## **615 Albany St Proposal**

### **MAY 7th SEDLC Meeting Comments and Notes:**

# Albany Street Residences

SIDING INFO

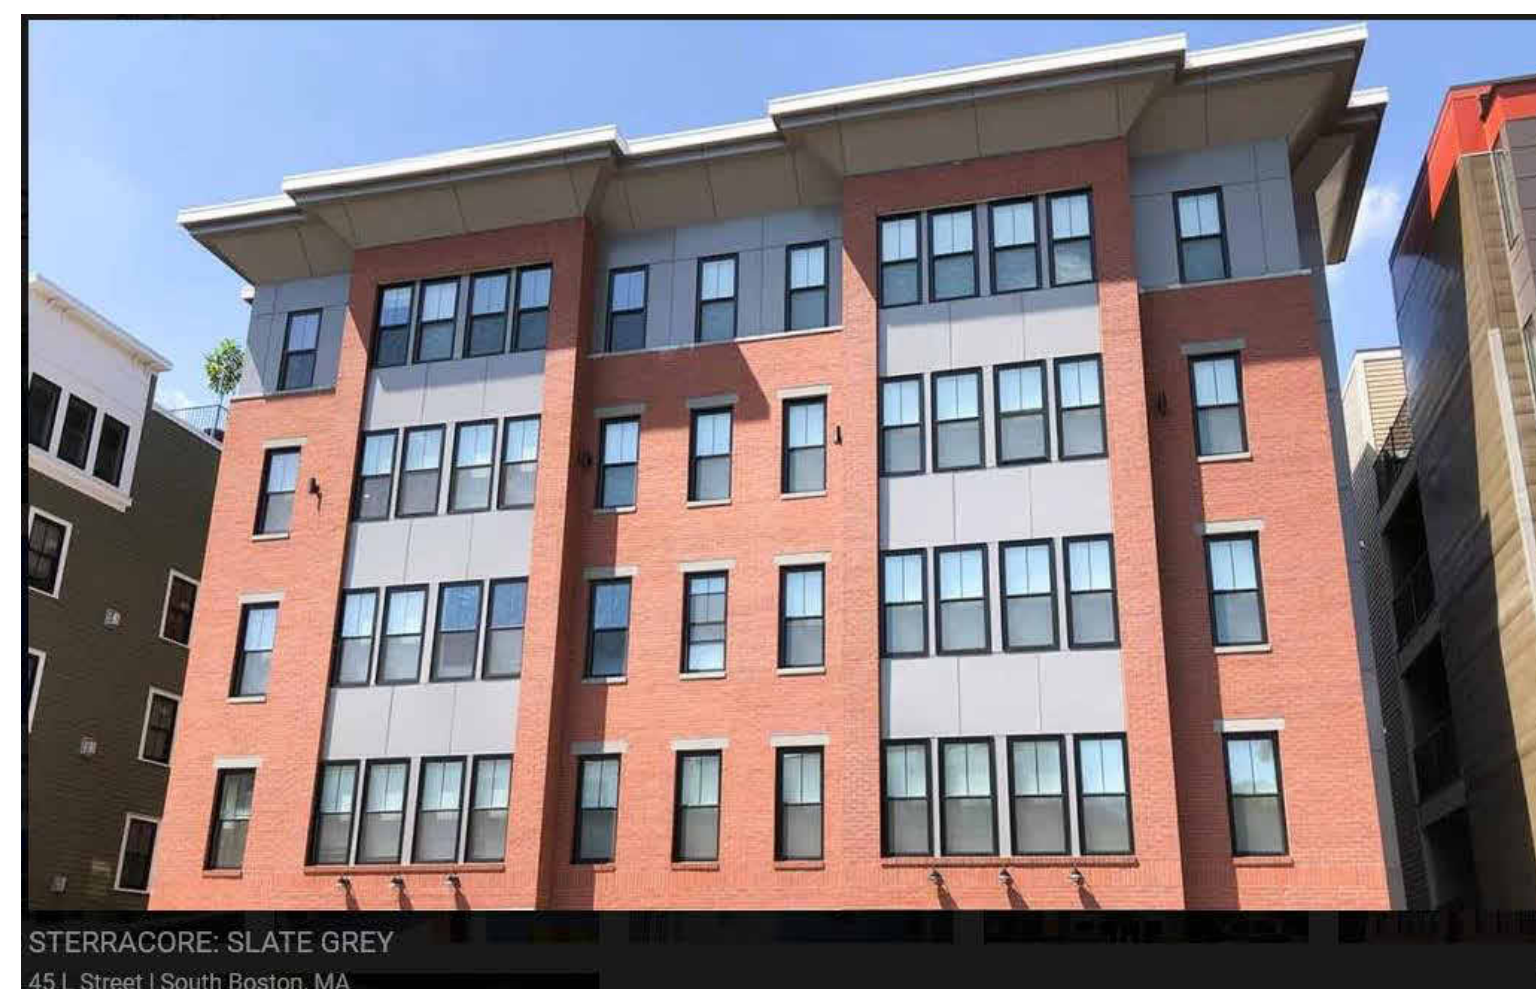
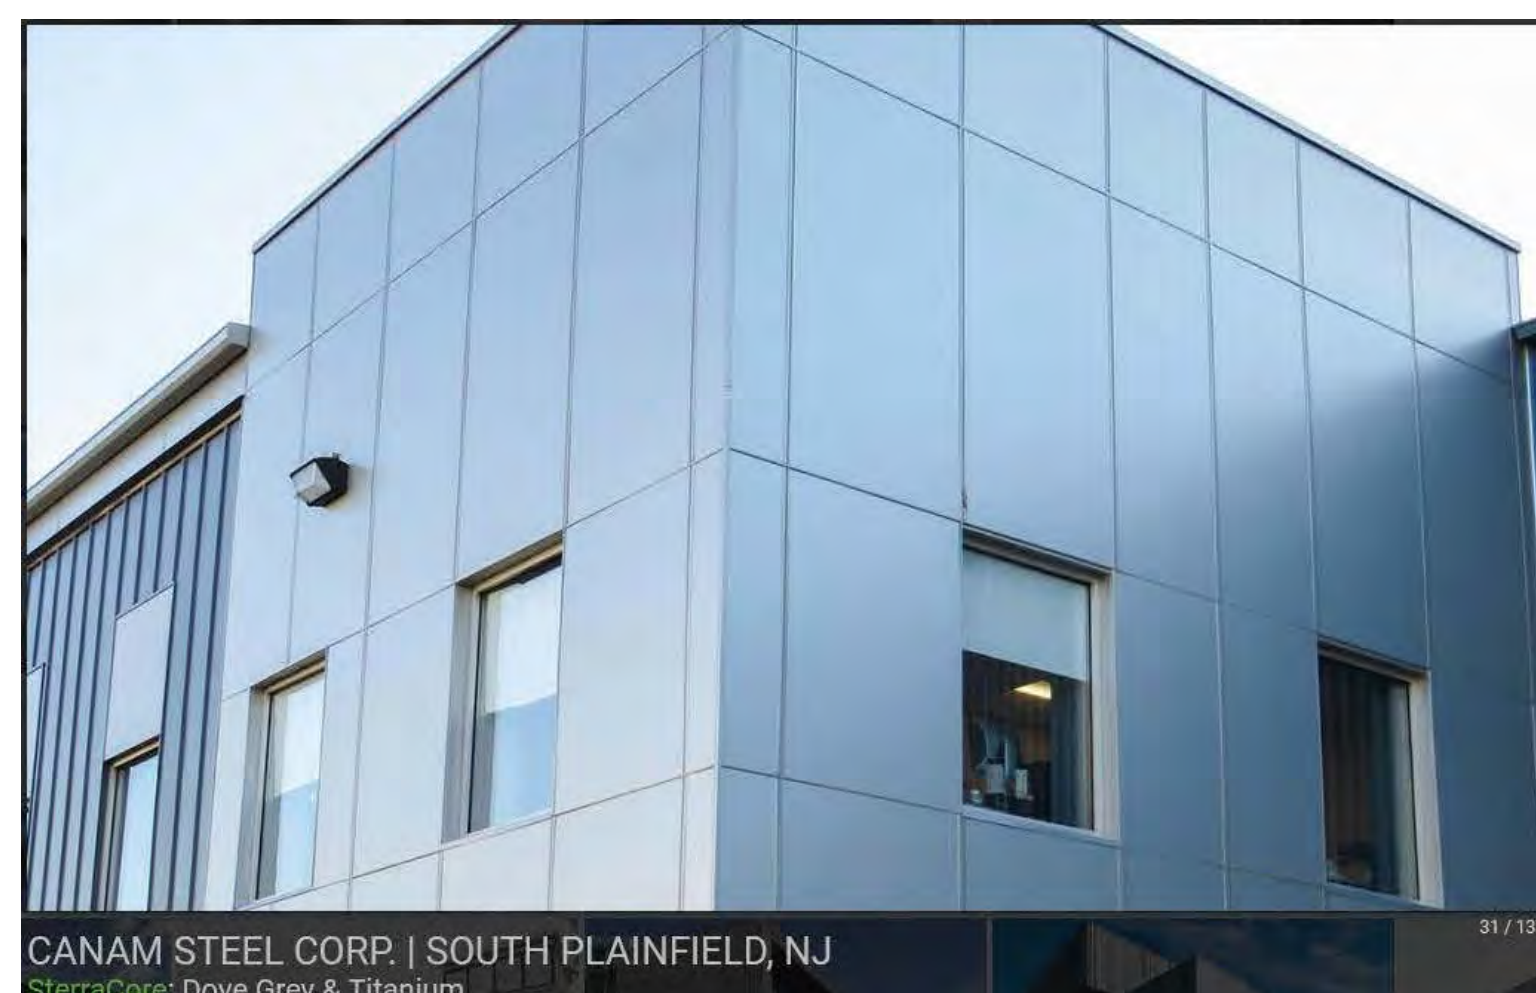
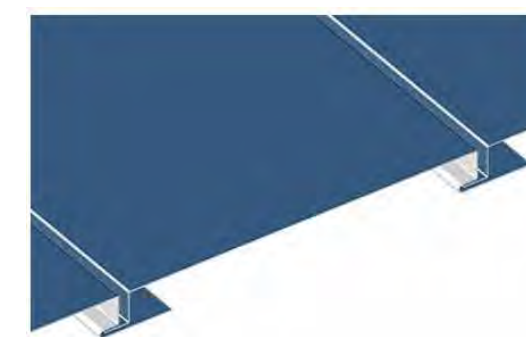
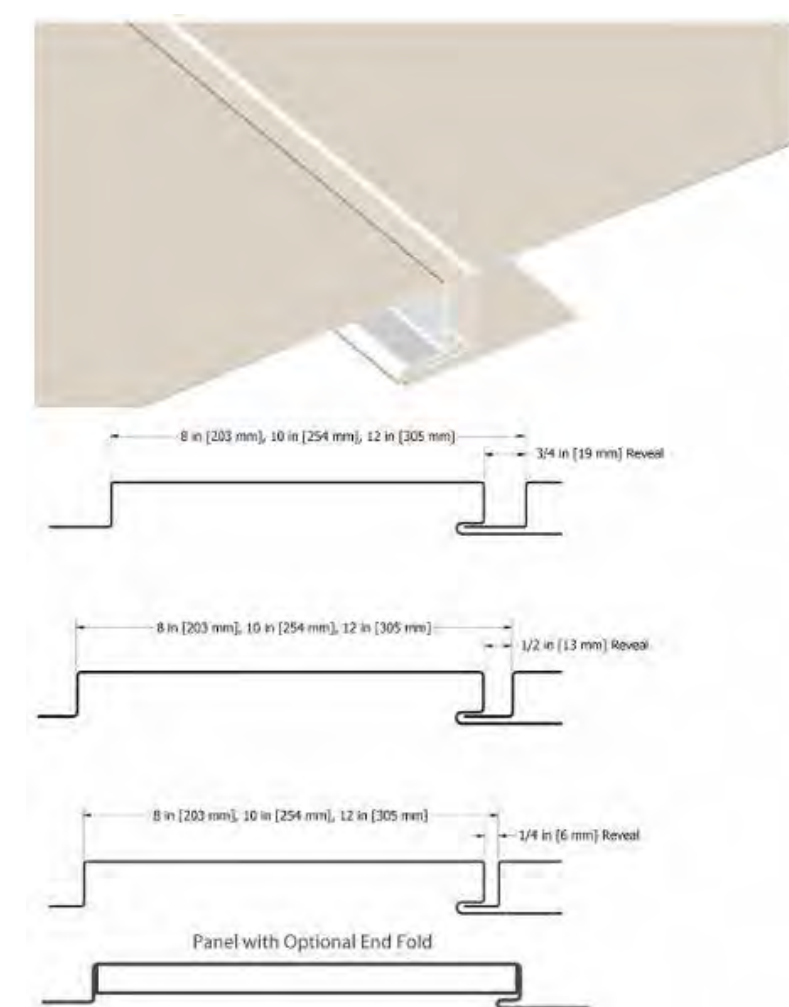
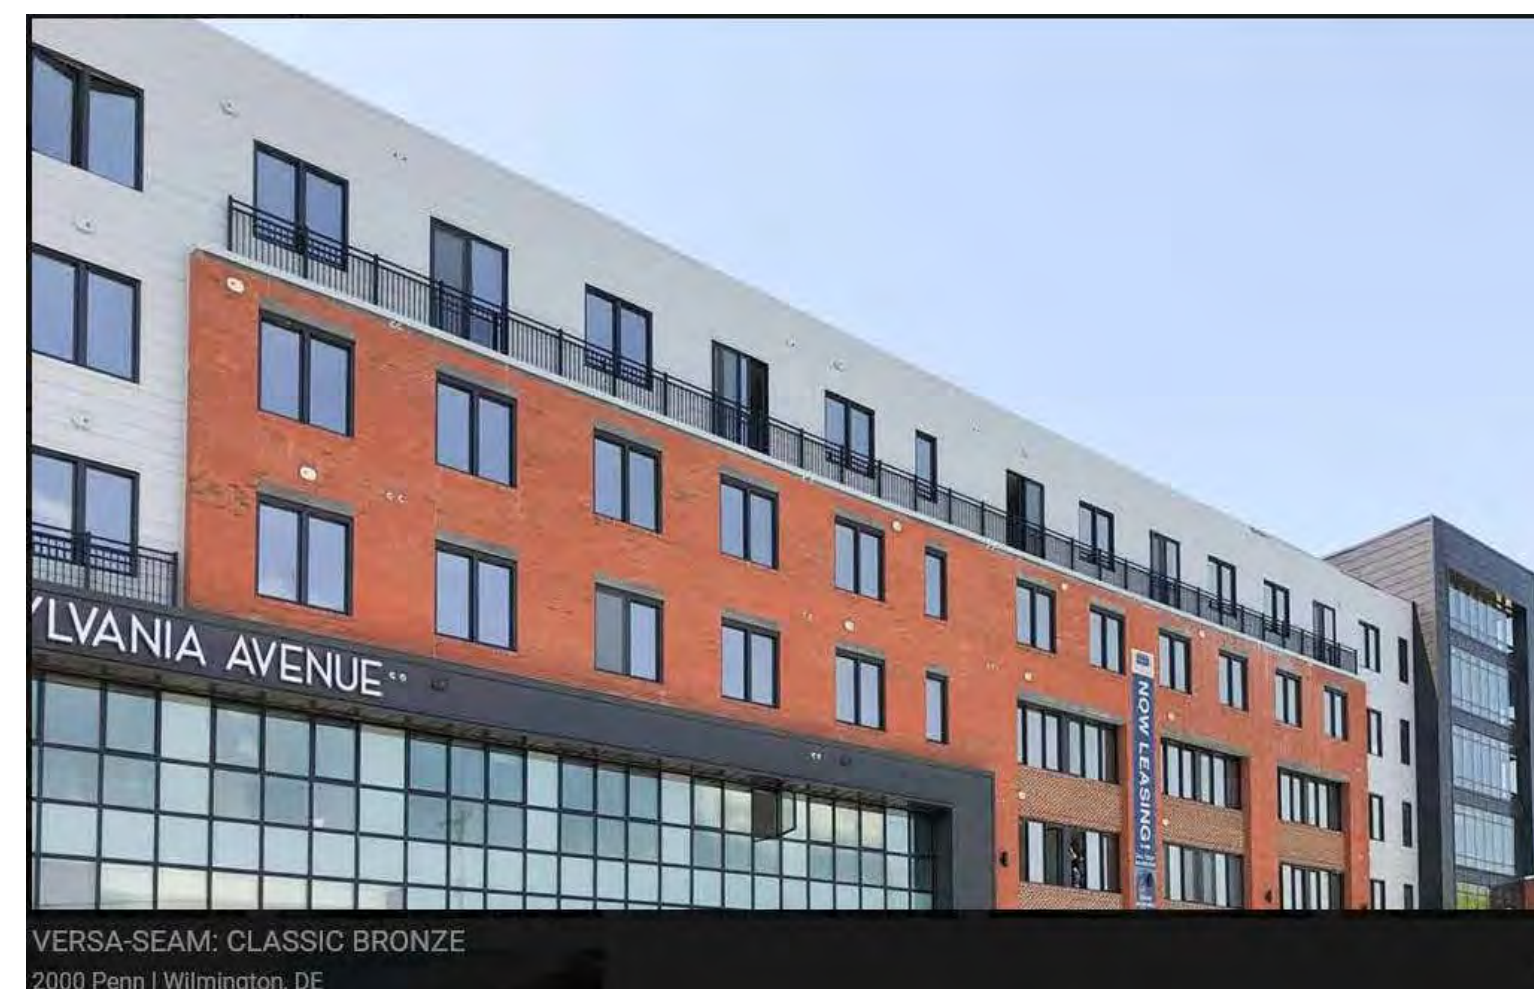
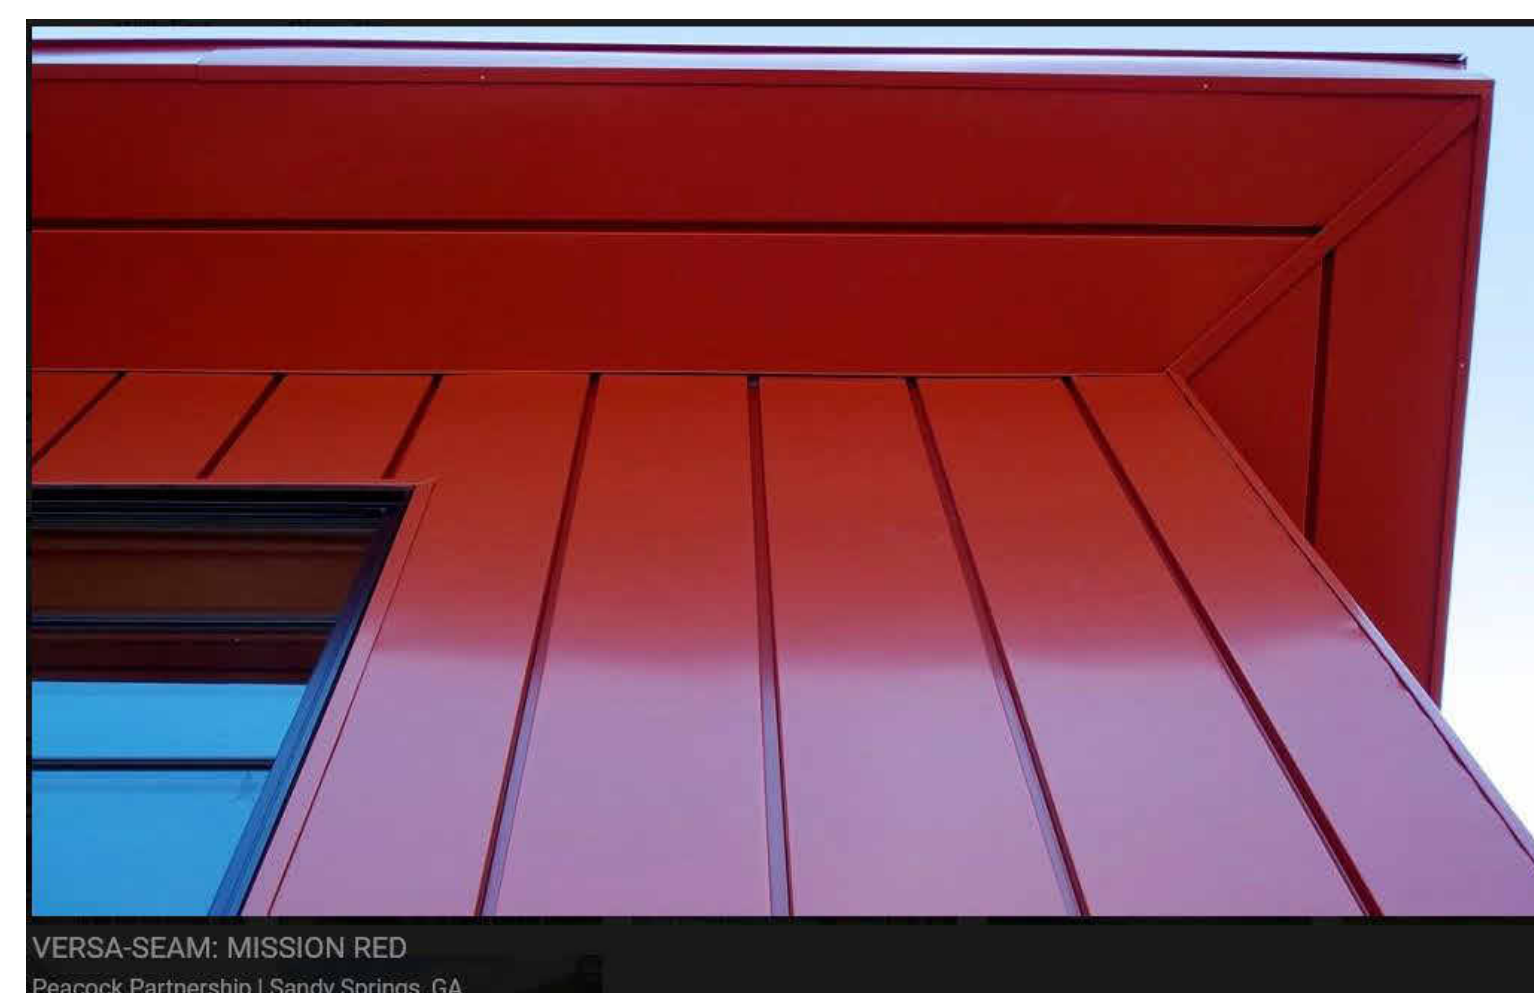
Siding alternatives of the egress stair tower were discussed. A vertical pattern with horizontal accents to break-up the vertical scale. A copper look was recommended if practical.

Discussions were had on alternative materials for the shaft and 5 & 6th story.

RESPONSE: A metal panel siding with a seam that offers a subtle shadow line has been proposed (Sterracore by Atlas Internation) with a vertical orientation. A subtle horizontal protrusion of the same material has been added to provide shadow lines that vertically scale down the tower to a more manageable proportion.

Response: The proposed siding at the stair tower, “pull-out” accents and roof top headhouse will be Sterracore by Atlas international that addresses the commercial scale of the neighborhood. The proposed siding of the remaining 5<sup>th</sup> and 6<sup>th</sup> floors will be Versa-Seam by the same manufacturer and offers a more residential scale and addresses the horizontal articulation of the existing brick below.
